E/ECE/324
E/ECE/TRANS/505 } Rev.1/Add.66/Amend.1
4 March 1994

Addendum 66 : Regulation No. 67

Amendment 1

UNIFORM PROVISIONS CONCERNING THE APPROVAL OF SPECIFIC EQUIPMENT OF MOTOR VEHICLES USING LIQUEFIED PETROLEUM GASES IN THEIR PROPULSION SYSTEM

FIGURE 1: Containers with longitudinal and circumferential welds, Location of test-pieces"

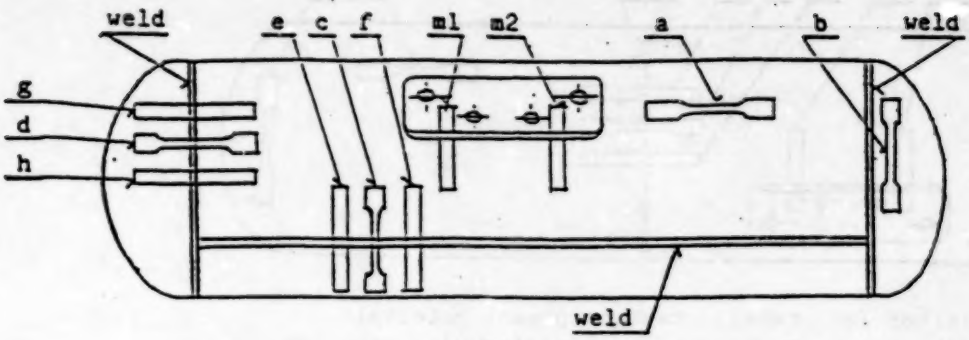
Annex 8, appendix 2,

Figure 1, replace by the following:

3.1.2.1.1. Containers with longitudinal and circumferential welds (three sections) on test-pieces taken from the places shown in figure 1 of appendix 2 of this annex:

(a) One tensile test on parent material; the test piece to be taken in the longitudinal direction (if this is not possible, it may be taken in a circumferential direction);
(b) One tensile test on parent material of the bottom;
(c) One tensile test perpendicular to the longitudinal weld;
(d) One tensile test perpendicular to the circumferential weld;
(e) One bend test on the longitudinal weld, the inner surface in tension;
(f) One bend test on the longitudinal weld, the outer surface in tension;
(g) One bend test on the circumferential weld, the inner surface in tension;
(h) One bend test on the circumferential weld, the outer surface in tension; and
- One macroscopic test of a welded section;
(m1, m2) A minimum of two macroscopic tests of valve boss/plate sections in case of the sidewall mounted valves referred to in paragraph 3.4.2. below.

FIGURE 2a: Containers with circumferential welds only and side-mounted valve blocks;
Location of test-pieces"

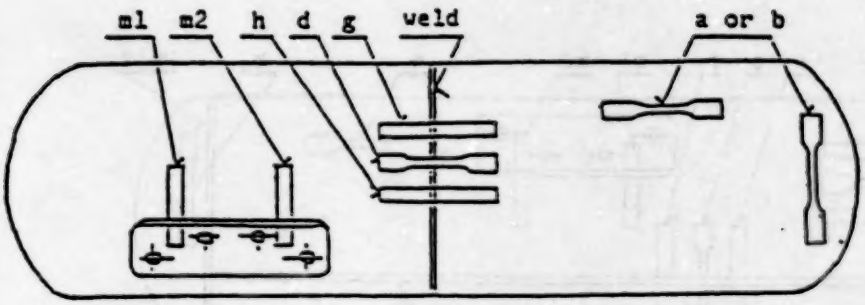
Add new figures 2a and 2b as follows:

3.1.2.1.2. Containers with circumferential welds only (two sections) on test-pieces taken from the places shown in figures 2a and 2b of appendix 2 to this annex:
The tests as specified in paragraph 3.1.2.1.1. above with the exception of (c), (e) and (f) which are not applicable. The test-piece for the tensile test on parent material shall be taken from (a) or (b) as mentioned in paragraph 3.1.2.1.1. above."
